SUBJECT: NuScale Power, LLC Response to NRC Request for Additional Information No. 132 (eRAI No. 8971) on the NuScale Design Certification Application

Response to Request for Additional Information

NRC Question No.: 03.08.04-13

Figure 4-12. Single Elements from Pool Gate Support Wall with Insufficient Thermal T0 Strain Capacity for Load Combination 9-6 in X Direction.

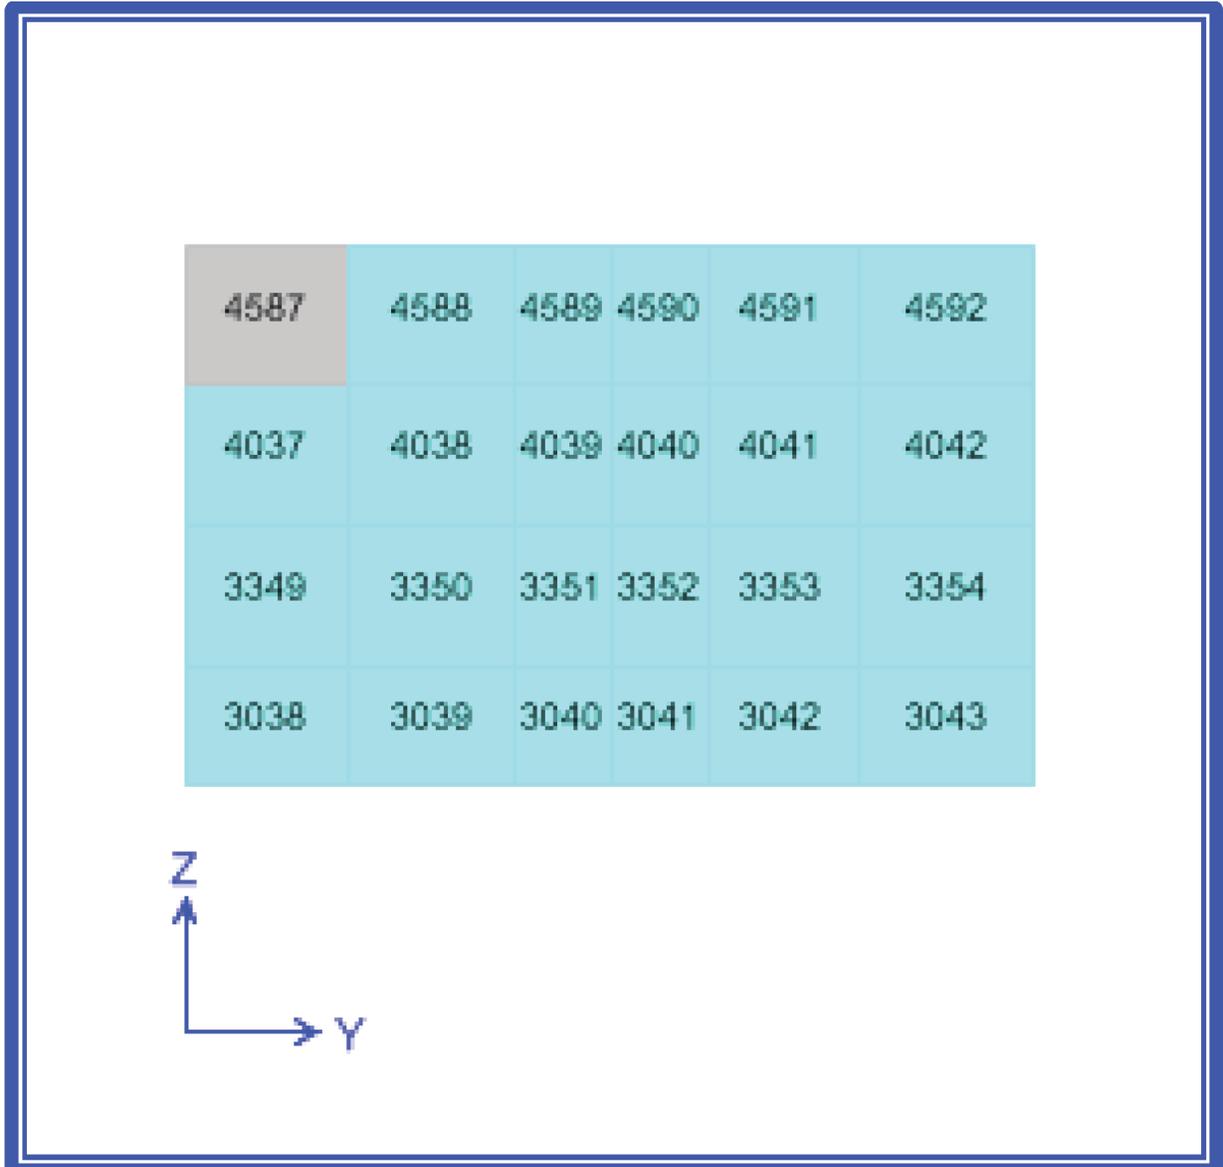
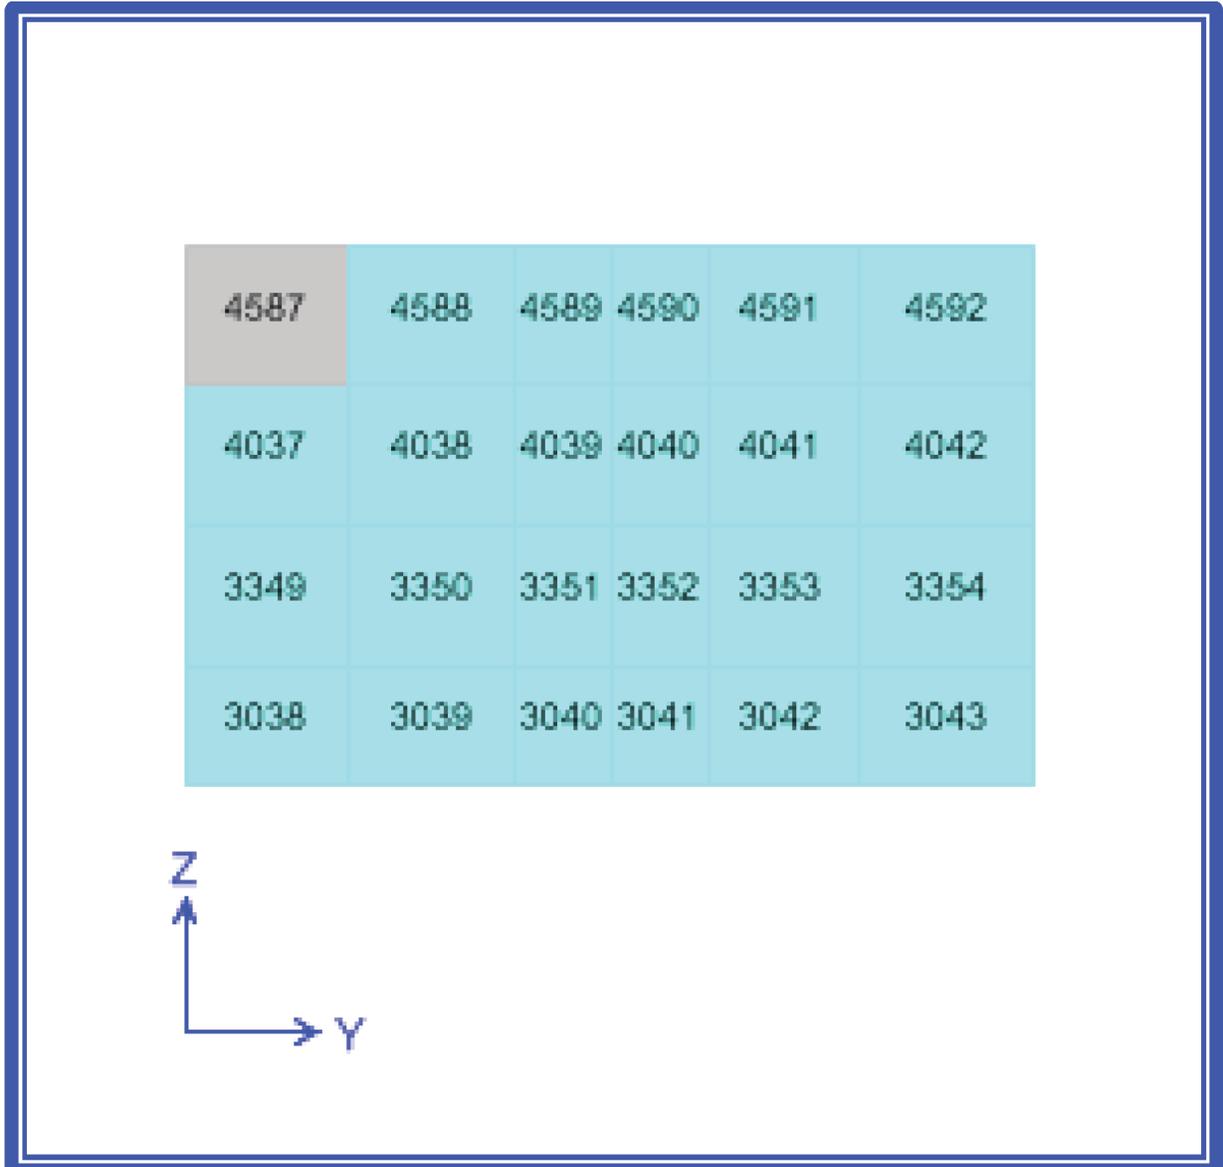
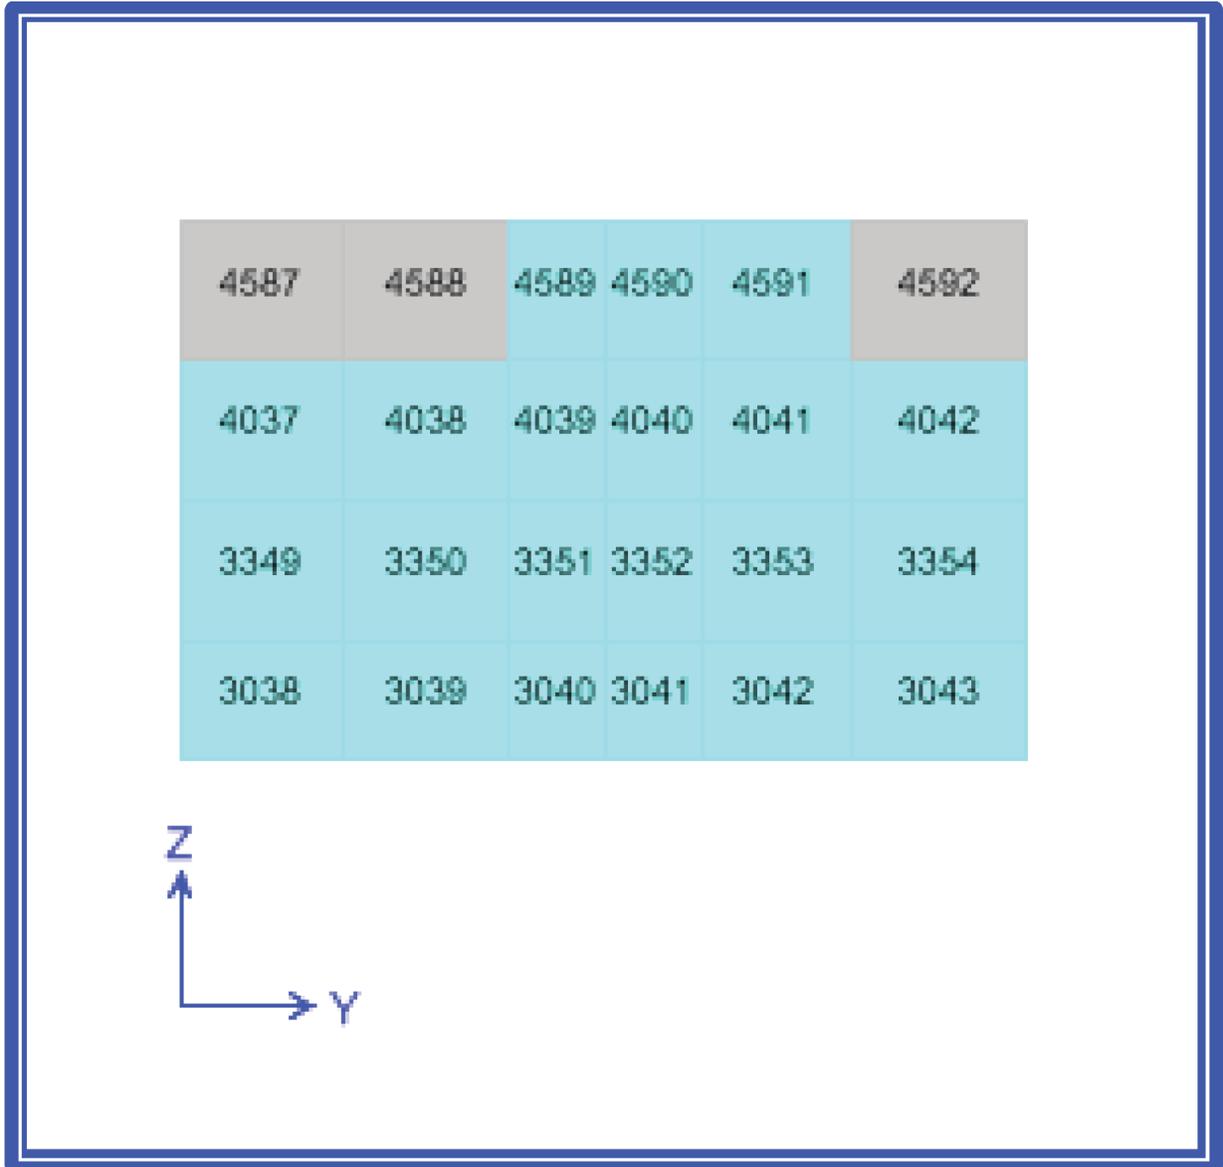
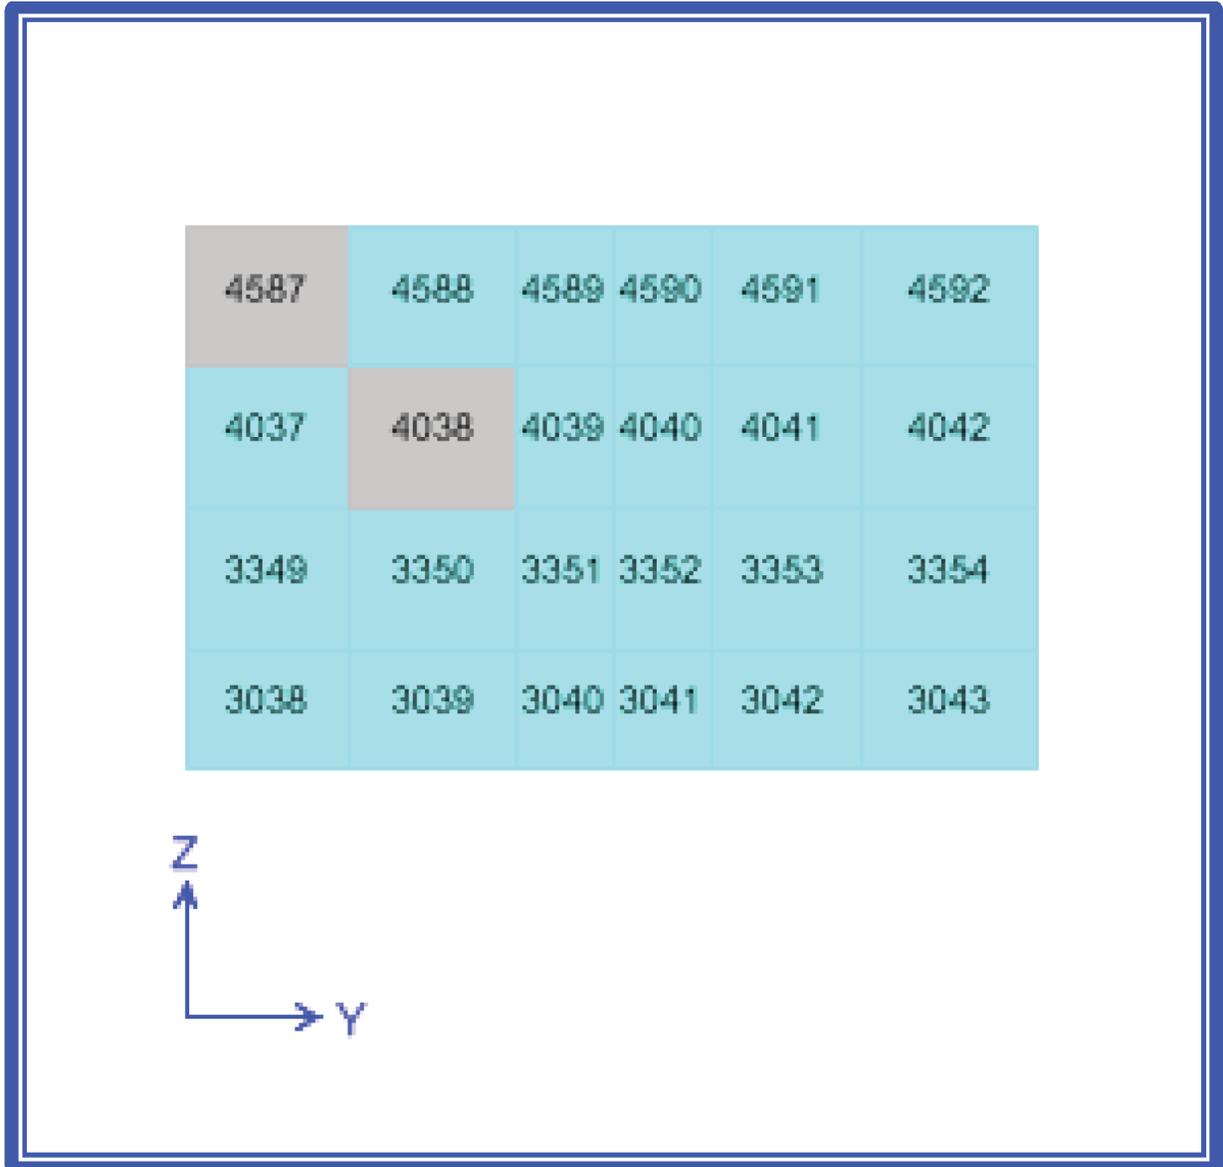
The total strain in the steel exceeds $1.2\varepsilon_y$ for both wall thicknesses for both load combination 9-6 and 9-9. Figure 4-12 through Figure 4-15 show the elements that exceed the allowable strain for combinations 9-6 and 9-9 in X and Y directions.

The total strain in the steel is less than $1.2\varepsilon_y(2.483 \times 10^{-3})$ after averaging the single elements without sufficient thermal capacity for load combination 9-6, therefore the condition is satisfied and the wall is considered acceptable. For groups of elements where adding the maximum strain from T_a+P_a would make the average fail, a more accurate T_a+P_a strain was obtained based on its location using the strain contour.

Figure 4-16. Single Elements from Roof Support Stiffeners with Insufficient Thermal T_0 Strain Capacity for Load Combination 9-6 in X Direction.

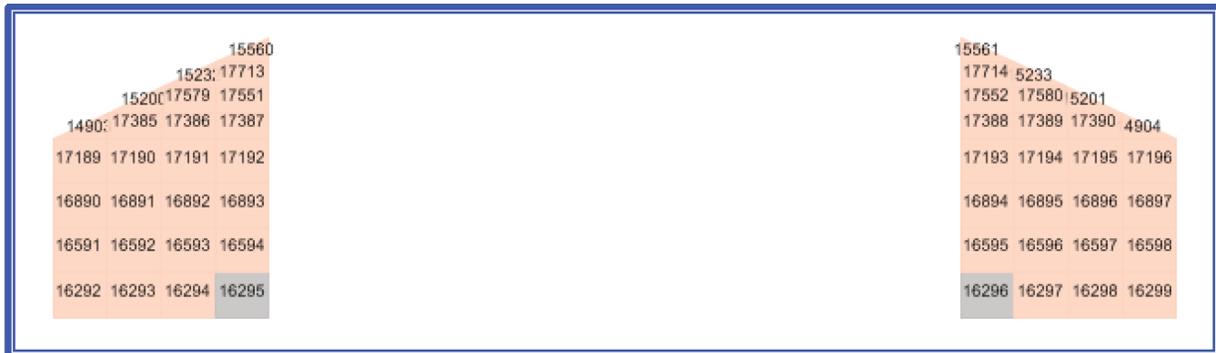
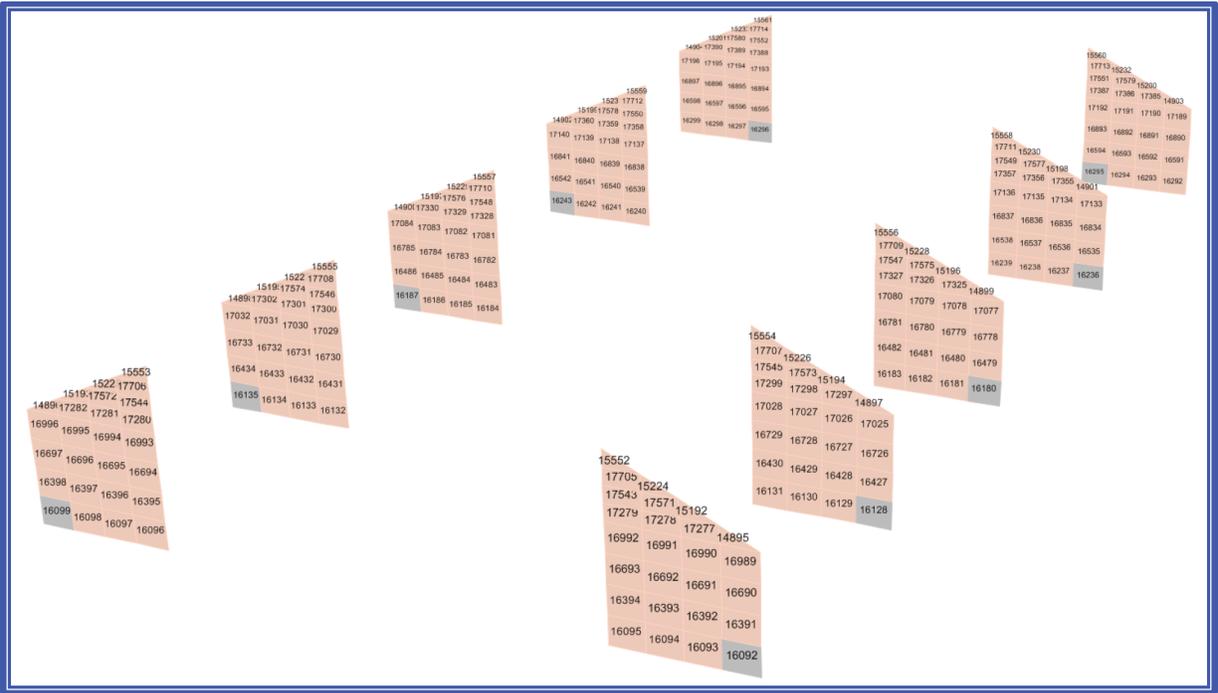
The total strain in the steel is less than $1.2\epsilon_y$ (2.483×10^{-3}) for only one type of reinforcement for load combination 9-6. The total strain in the steel exceeds $1.2\epsilon_y$ (2.483×10^{-3}) for all other reinforcement types. Figure 4-16 and Figure 4-17 show the roof support stiffeners with insufficient thermal capacity in X direction for load combinations 9-6 and 9-9 respectively. The total strain in the steel is less than $1.2\epsilon_y$ (2.483×10^{-3}) after averaging the single elements without sufficient thermal capacity for both load combinations 9-6 and 9-9, therefore the condition is satisfied and the wall is considered acceptable.

Figure 4-18. Single Elements from NPM Support Walls with Insufficient Thermal T_a+P_a Strain Capacity for Load Combination 9-9 in X Direction.

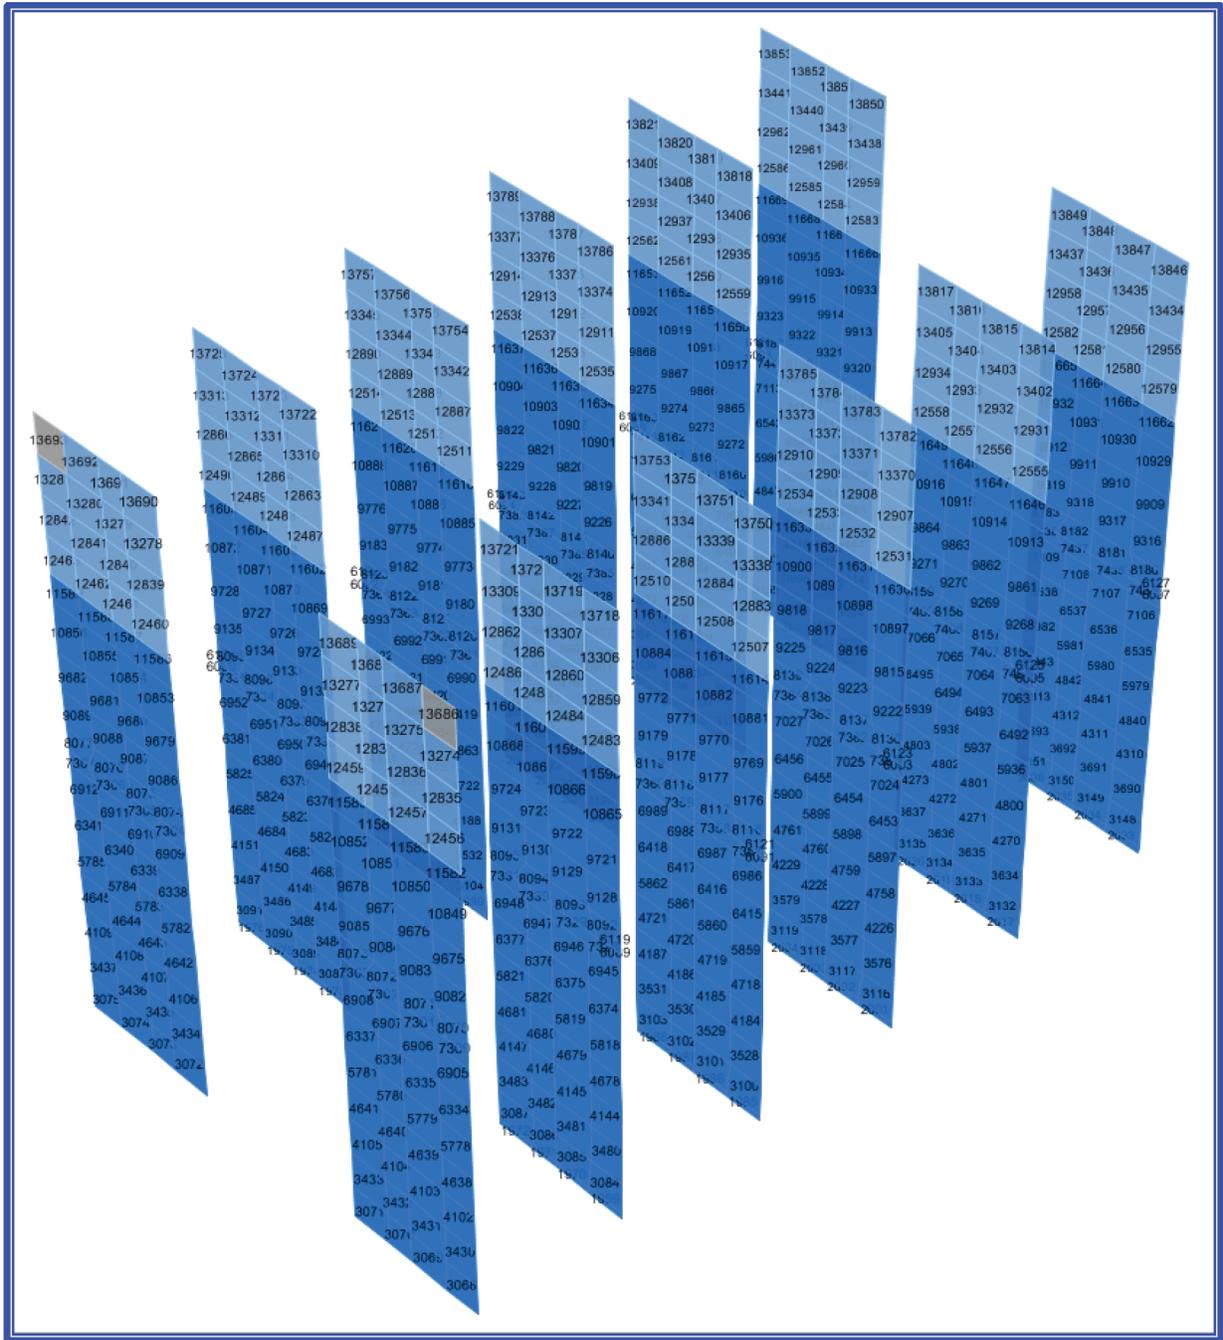
As shown in Table 7-41, the total strain in the steel is less than $1.2\epsilon_y$ (2.483×10^{-3}) at all locations for load combination 9-6. However, the total strain in the steel exceeds $1.2\epsilon_y$ (2.483×10^{-3}) for one type of reinforcement for load combination 9-9. An averaging for these exceeding elements shown in Figure 4-18 is performed.
